AGENDA
CITY OF KENTWOOD PLANNING COMMISSION
TUESDAY, JULY 27, 2021
KENTWOOD COMMISSION CHAMBERS
4900 BRETON AVENUE
7:00 P.M.

PROPOSED MINUTES OF THE REGULAR MEETING
OF THE KENTWOOD PLANNING COMMISSION
TUESDAY JULY 13, 2021, 7:00 P.M.
COMMISSION CHAMBERS

STAFF REPORT: July 12, 2021
PREPARED FOR: Kentwood Planning Commission
PREPARED BY: Lisa Golder
CASE NO.: 20-21 DMS IPUD

To: Kentwood Planning Department
From: Brad Boomstra, P.E.
City Engineer
Date: July 13, 2021
Re: **DMR Transportation**
4401, 4375, 4251 36th Street SE
41-18-13-400-004, 41-18-13-390-027, & 41-18-13-390-026
Review of Site Plan Received 7-12-2021

CONSUMERS ENERGY R/W

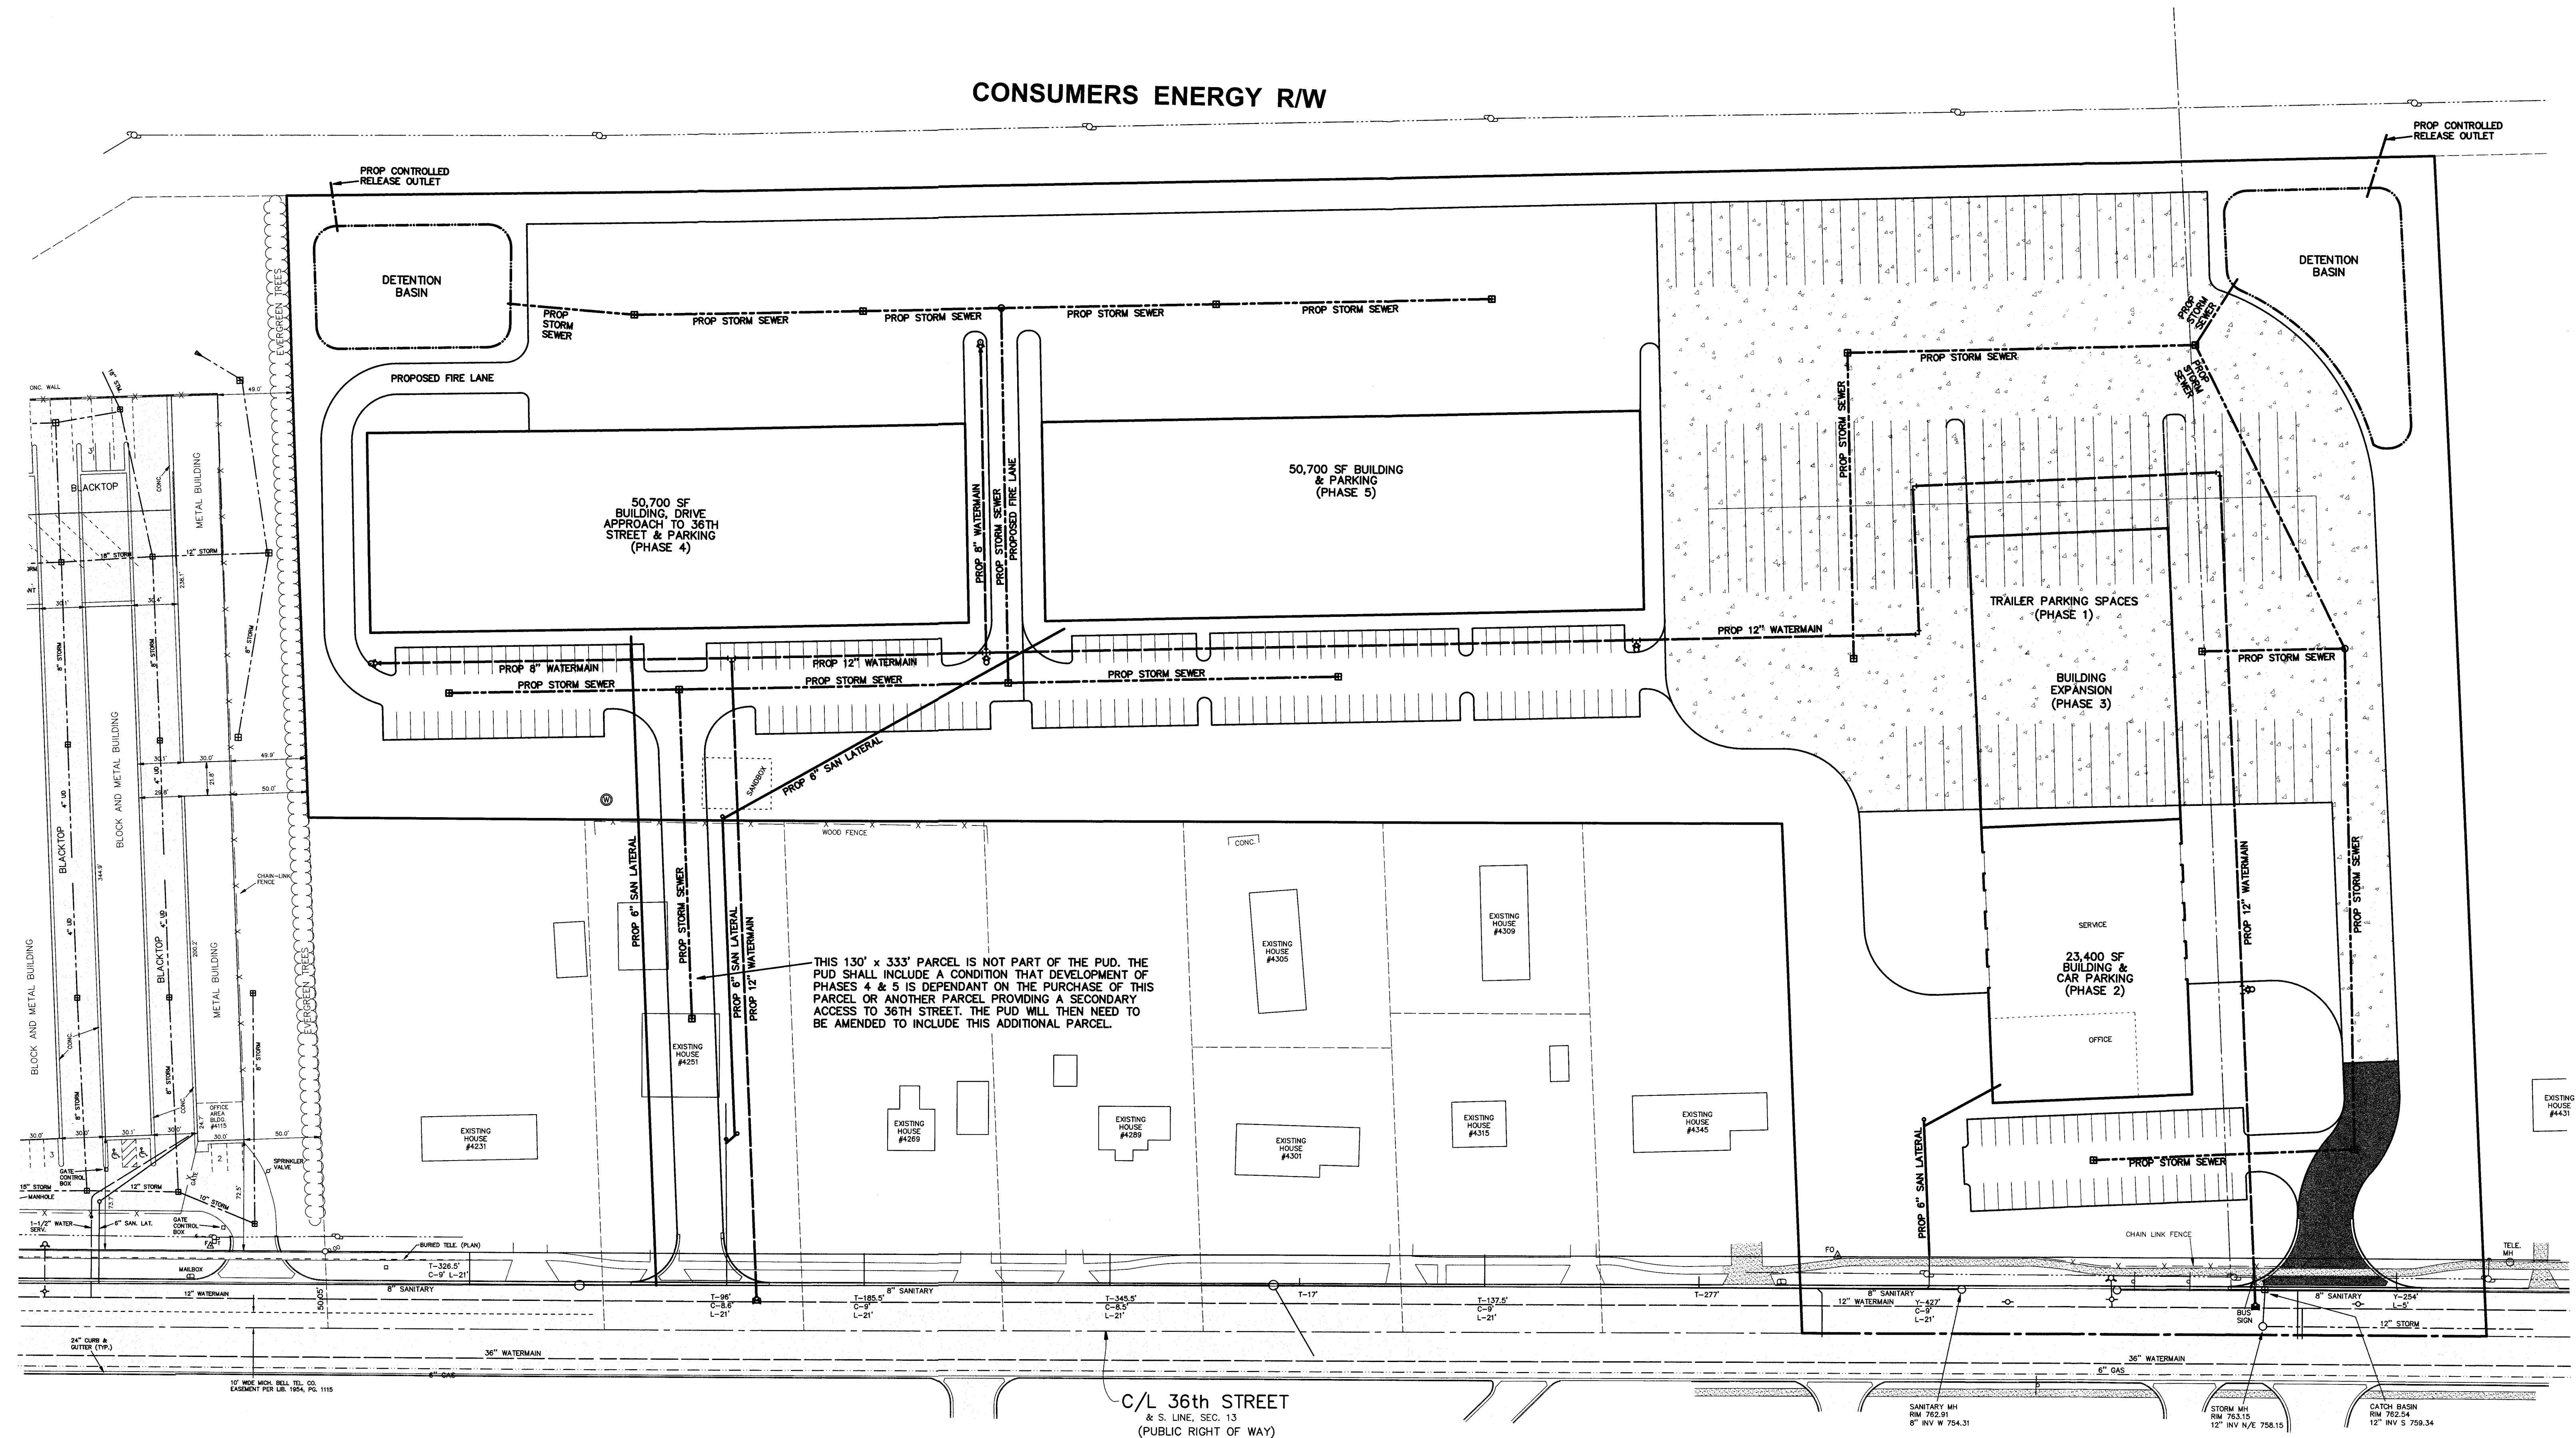
While there is not enough information to provide a complete review, Kentwood Engineering has the following comments that will need to be addressed before site plan construction review.

1. Include parcel numbers on the plans.
2. The cover sheet, watermain and sanitary sewer plan sheets must be prepared in accordance with the City of Grand Rapids drafting standards. Any improvement sheet(s) listed in the sheet index on the cover sheet must include the words, "FOR REFERENCE ONLY".
3. The multiple parcels at this site must be combined into a single parcel. This is required whenever new development spans across adjacent parcels. Please contact the Kentwood Assessor, regarding this procedure.

1. The pavement within the commercial drive approach between the sidewalk and the gutter pan must be concrete at least 6 inches thick.
2. No single curb cut shall be less than 10 feet in width, nor more than thirty (30) feet in width.
3. For any curb cut which terminates less than five (5) feet from a construction joint, the contractor shall remove and replace the existing curb to the next joint.
4. Include the City of Kentwood General Notes on the plan(s). These notes are required for the work being performed in the 36th Street right-of-way. Highway permit conditions, specifications and required general plan notes are posted on the City's website, and can be accessed at <http://www.ci.kentwood.mi.us> (hover over "CITY SERVICES" and "DEPARTMENTS" then click "ENGINEERING", then click the "RIGHT-OF-WAY" link near the top of the page).
